Date: July 24, 2015

To: Plan Holders – Healdsburg Intermodal Facility

Re: **Addendum No. 4. – 6 Items**

Addendum 4, Item 2 – Updated Plan Sheets D-1.1 and SP – 1.1

D1.1
OF 31

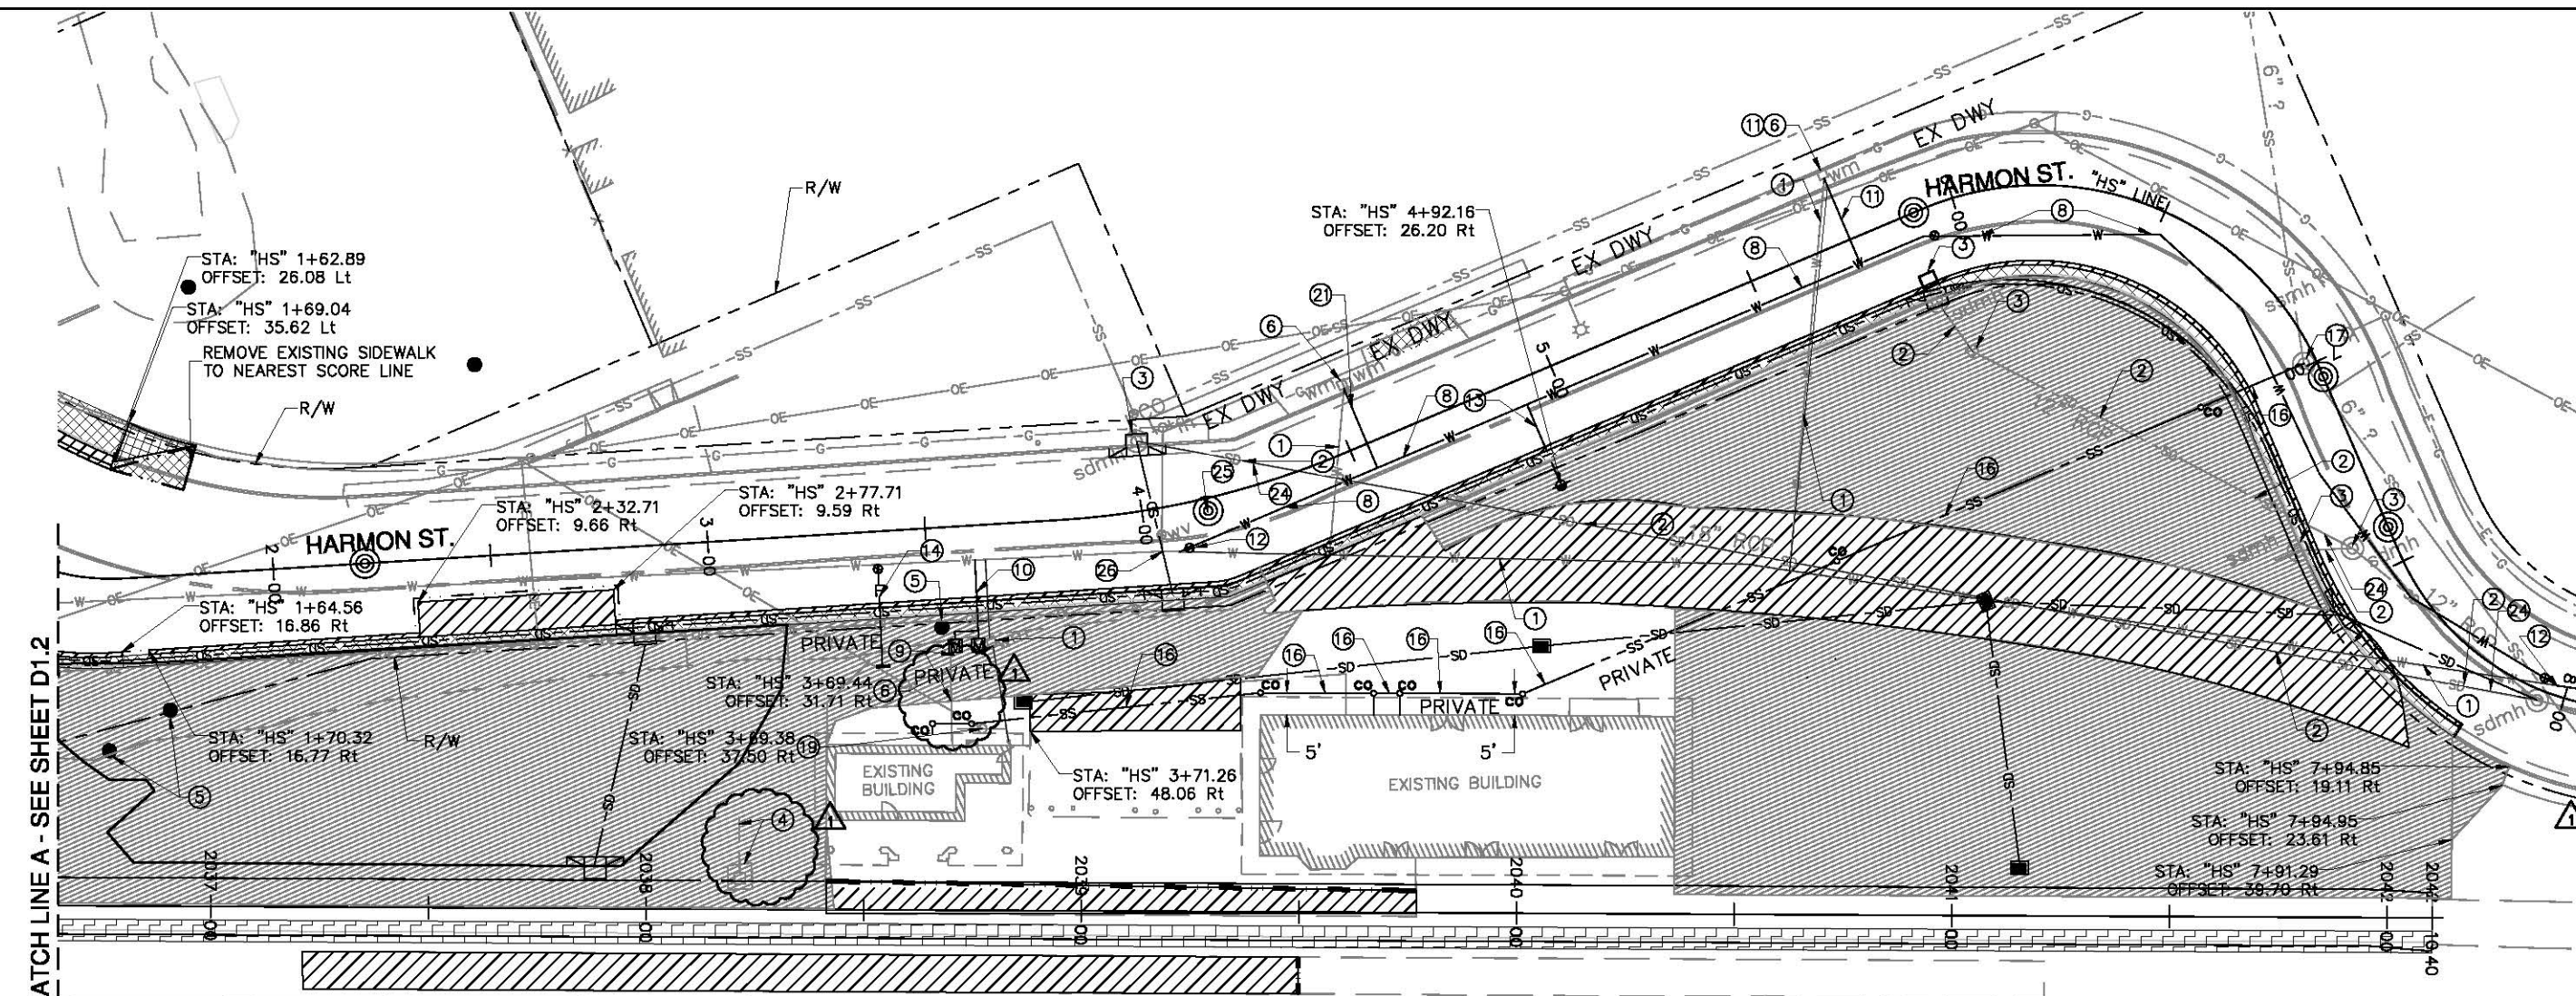
The revision on these two plan sheets are marked with a cloud and referenced in the revision block.
